Project	IEEE 802.16 Broadband Wireless Access Working Group < http://ieee802.org/16 >	
Title	Correction to Section 8.4.8.3 (Figure 232—Illustration of STC)	
Date Submitted	2004-11-11	
Source:	Nageen Himayat, Shilpa Talwar, Hassan Yaghoobi	mailto: nageen.himayat@intel.com mailto: shilpa.talwar@intel.com mailto:hassan.yaghoobi@intel.com
	Intel Corporation CHP3-105 350 East Plumeria Dr. San Jose, CA 95134	
Re:	IEEE 802.16e/D5	
Abstract	Proposed Correction to Section 8.4.8.3 (Figure 232). Figure 232 related to space time coding is inconsistent with Figure 244 of 802.16d D5. We propose that Figure 232 be aligned with 802.16d D5.	
Purpose	802.16e Sponsor Ballot	
Notice	This document has been prepared to assist IEEE 802.16. It is offered as a basis for discussion and is not binding on the contributing individual(s) or organization(s). The material in this document is subject to change in form and content after further study. The contributor(s) reserve(s) the right to add, amend or withdraw material contained herein.

Correction to Section 8.4.8.3 (Figure 232)

Figure 232---Illustration of STC for Optional Zones in DL

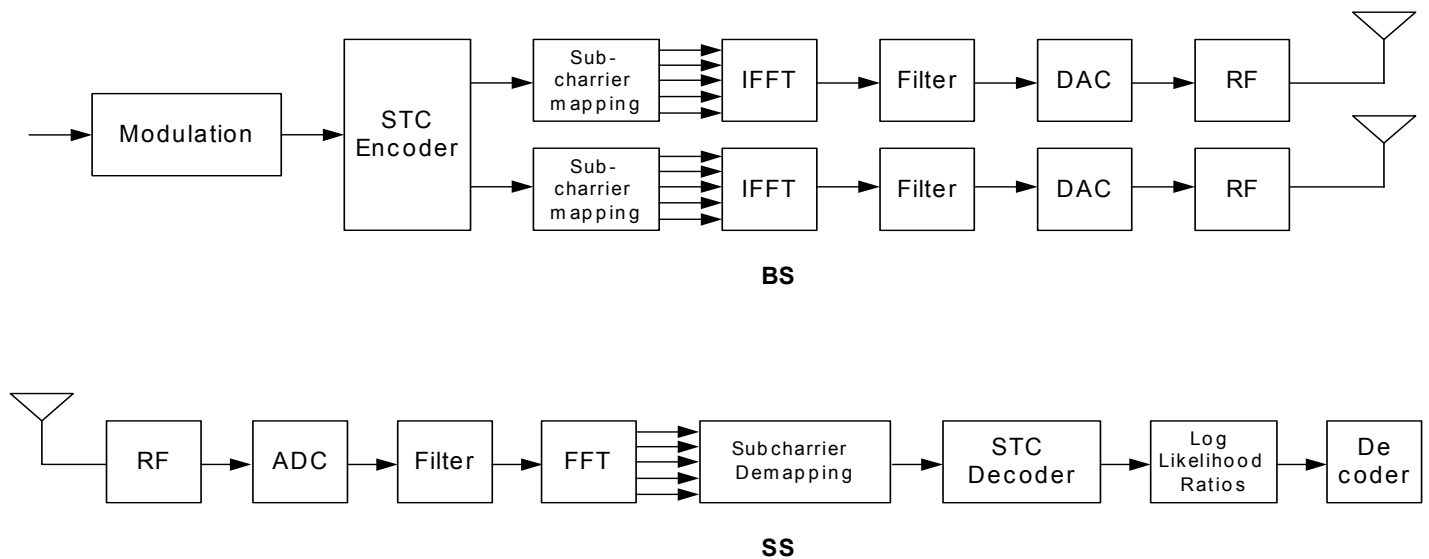
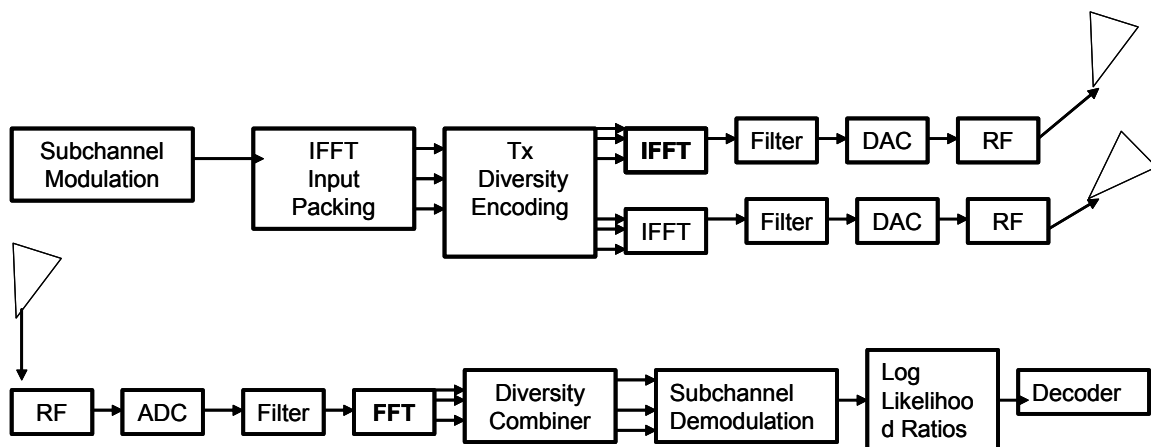
Figure 232 in Section 8.4.8.3 of 802.16e D5, illustrating the use of transmit diversity, is inconsistent. The figure, as reproduced below, shows that space-time coding is carried out before the sub-channel mapping operation. Whereas Figure 244 in section 8.4.8.1 in 802.16d D5, shows that STC encoding is carried out after the sub-carrier mapping operation. We propose that Figure 232 be corrected according to Figure 244 of 802.16d D5.

Figure 244 in section 8.4.1 of 802.16d D5 is shown below.
